## Jersey Jack Pinball

DATE: June 1, 2019 GAME: Pirates of the Caribbean Pinball SUBJECT: Post Update Kit.

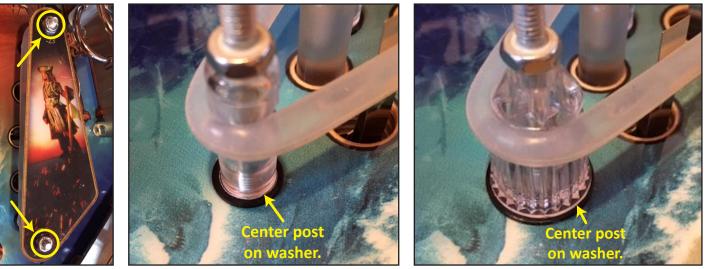
The updates detailed in this JJP Service Bulletin should be made to your Pirates of the Caribbean game to prevent damage to the main playfield clear coat and artwork, around the lower sling posts.

1) Using an 11/32" nutdriver, remove the two locknuts holding lower right sling plastic in place (see picture below, left). Remove silicone ring from sling posts.

2) Using a 5/16" nutdriver, remove two corner (upper and lower) sling posts.

3a) *If there is no (or minimal) damage to the PF around these posts,* add a 0.49" OD black washer under the posts and firmly reattach them to the PF. Ensure that each post remains centered on its washer as you tighten it down (see picture below, center).

3b) *If PF damage around these posts is more significant,* replace the original posts with star posts. Add 0.75" OD black washers underneath and firmly attach them to the PF. Ensure that each post remains centered on its washer as you tighten it down (see picture below, right). Check and readjust your sling switches as necessary.
